PARISH OF ASCENSION
OFFICE OF PLANNING AND DEVELOPMENT
PLANNING DEPARTMENT

Planning Commission

March 9, 2016 - 6:00 PM

AGENDA

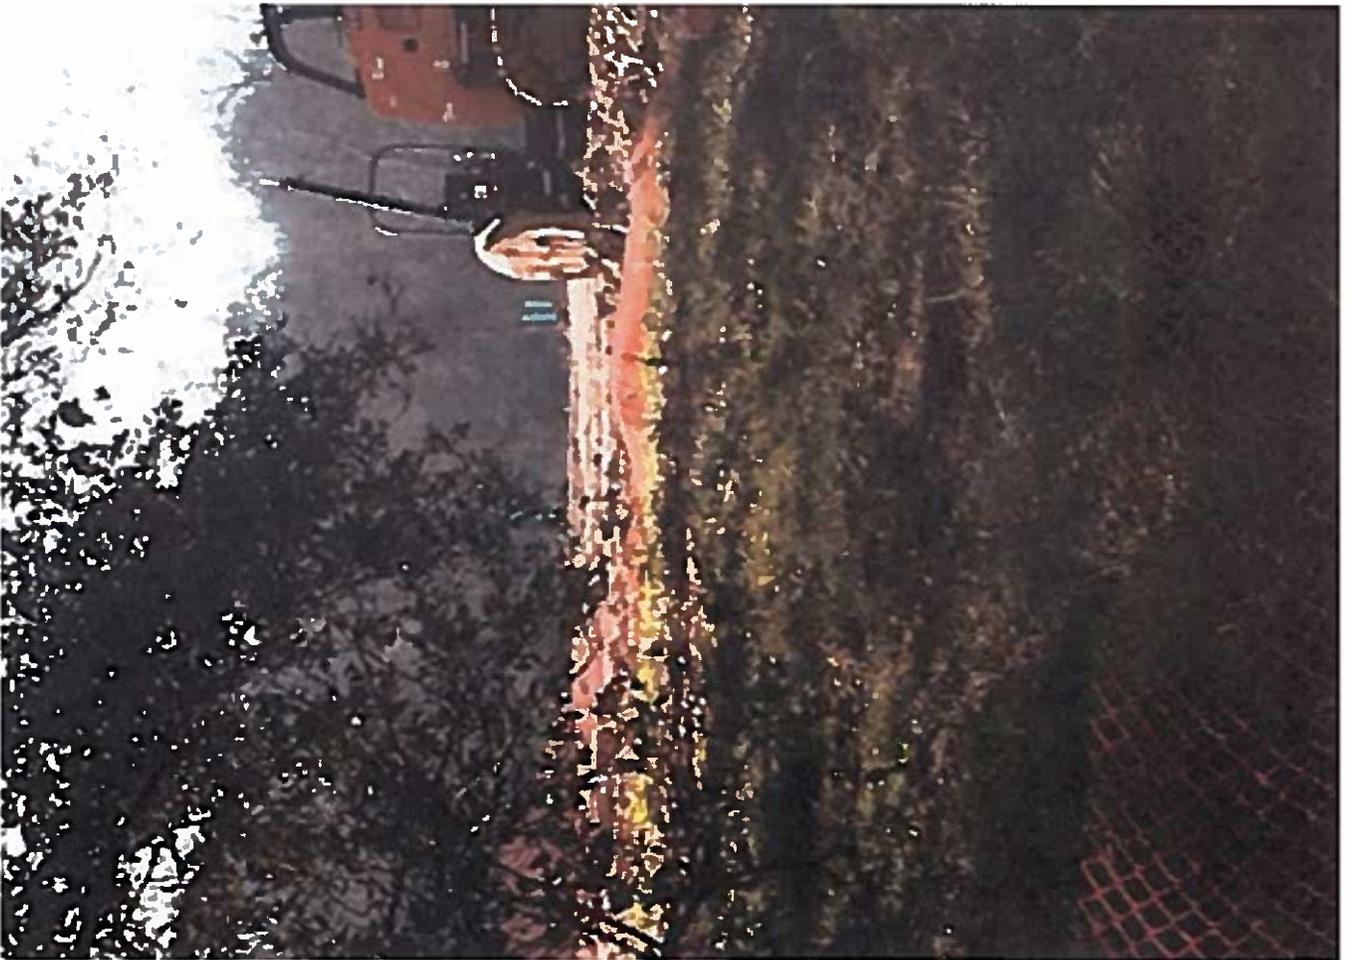
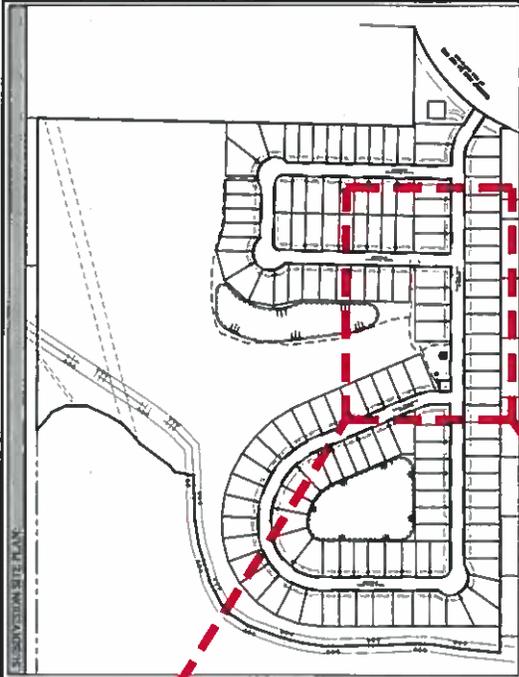
1. The 1x4 wood rails along the walking trail were not constructed in accordance with Section 17-4020 (G): “Where ends of 2 rails meet, at least 12” of 1”x 4” material shall be used as an overlap on the outside of the trail for additional support.”
2. The turn lane onto Grand Wood Ave. has not yet been striped
3. Sign must be provided for park area in accordance with 17-4020 H.6.
4. Sidewalk is not installed at common area on west side of entrance (near treatment plant). Sidewalk at east side is broken. – must be replaced
5. The length of trail running N-S behind lots 15-18 has not been constructed.

- End of First Filing, across from wet well-lift station on left of street, there are 4-6 lots that do not have electrical service. This must be addressed in order to pass inspection.
- Area at lift station with no electrical service.
- Side walk broken on left side on corner of second street.
- Walking trail not completed
- Sidewalk broken on left side of street at entrance.
- Electrical stub out for electricity to sewer treatment plant has not been completed.
- Need lot grading.
- Hydromulch need to be behind curve to sewer stacks.
- Final dress on pond and hydromulch.
- Need striping on turn lane and dress slope on turn lane.
- Need sign for the park.
- Need fence around wet well and sewer treatment plant.
- Curb broken near Coontrap.
- Clean up front ditch along Coontrap.
- Need 1"x4"x12" overlap on walking trail boards.

The preliminary plat does not currently match the final plat if there are 6 lots without electricity within the proposed filing. Both maps will need to be revised prior to final plat signature.

Planning Commission needs to make a decision about the ultimate routing of the proposed trail system – as it is currently constructed, it is incomplete and based on how it was planned/designed, it cannot be built as shown.

Staff recommends approval of this final plat contingent upon satisfactory completion of all outstanding items listed above, posting of maintenance bond, and the engineering department receiving and approving as-built drawings, engineer's certification, testing reports, etc.
